CHILDCARE CENTRE – 34-36 ST MICHAEL TERRACE, MOUNT PLEASANT NEW DEVELOPMENT

Road Safety Audit Stage 2 - Preliminary Design

Audit Ref: 2511014-RSA-001

Figure 5.7: Clearances between cyclist envelope and potential path hazards

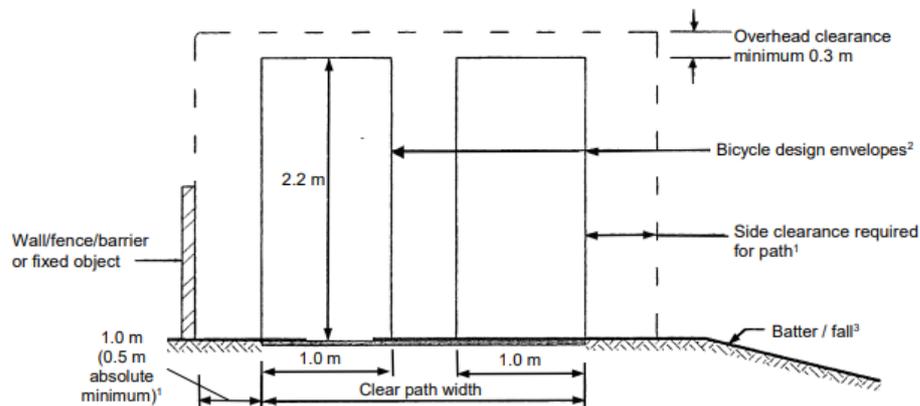
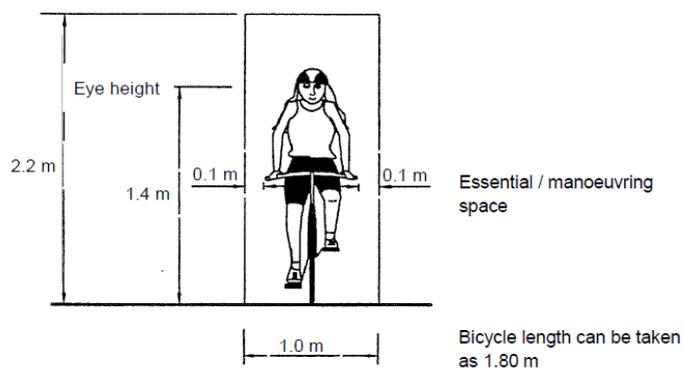
It was noted that there is a service cover protruding above ground and onto the footpath, with no detail on the drawings if the service cover will be relocated.

Service covers protruding above the ground and within the footpath creates a tripping hazard and is within the required clearance from the path. This would also create a hazard for cyclist causing a run-off crash resulting in serious injury.

Austrroads Guide to Road Design Part 6: Paths for Walking and Cycling indicates that the clearances (Figure 5.7) may be used to construct the appropriate width of the facility required for paths that cyclists use. The envelope based on Figure 3.5, is assumed to be consistent over the range of operating conditions and allowance for higher speeds is provided through larger clearances to other cyclists and fixed objects beside the path.

Relocate the service cover outside of the required clearance from the edge of path.

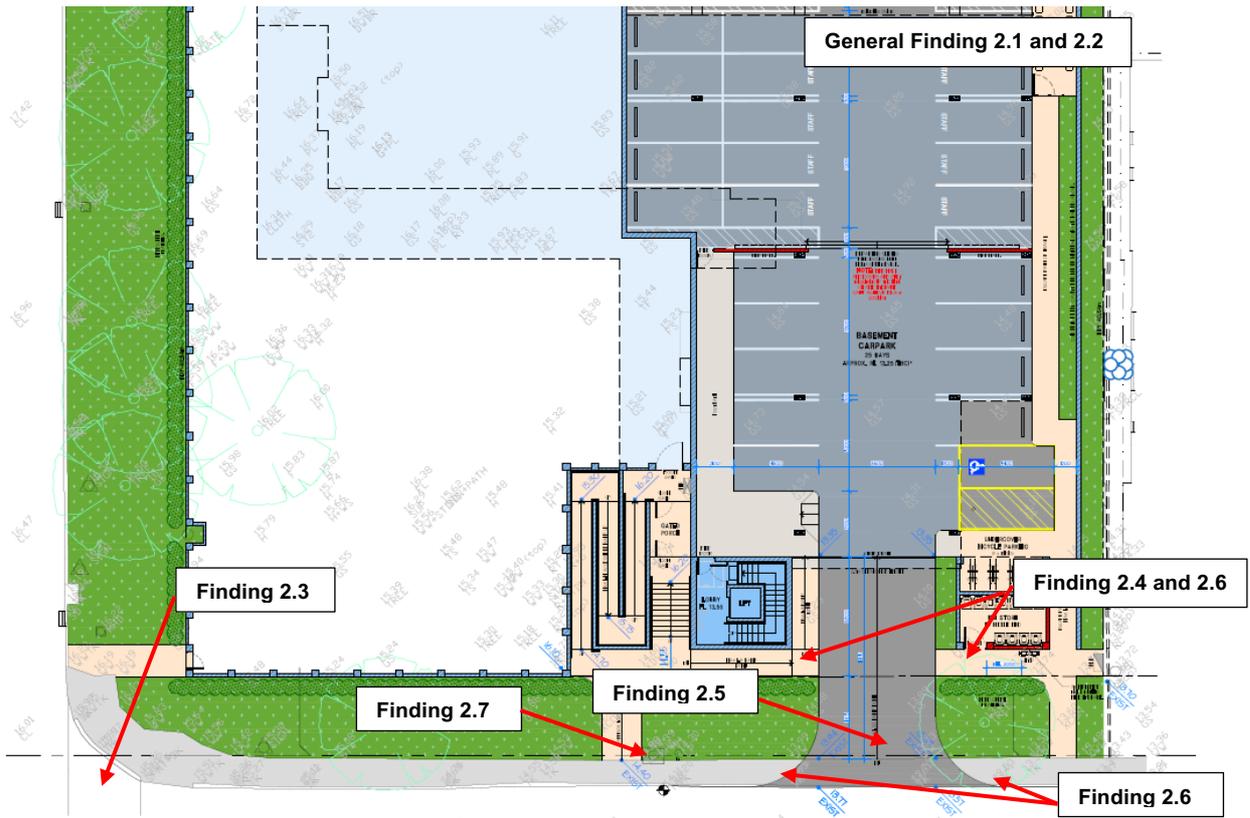
It was noted that there were non-frangible trees adjacent to St Michael Terrace and Queens Road within the clear zone.

Ensure that the required clear zone is provided as per the MRWA supplement to Austrroads GRD 6, or that vehicles are protected by a suitable safety barrier.
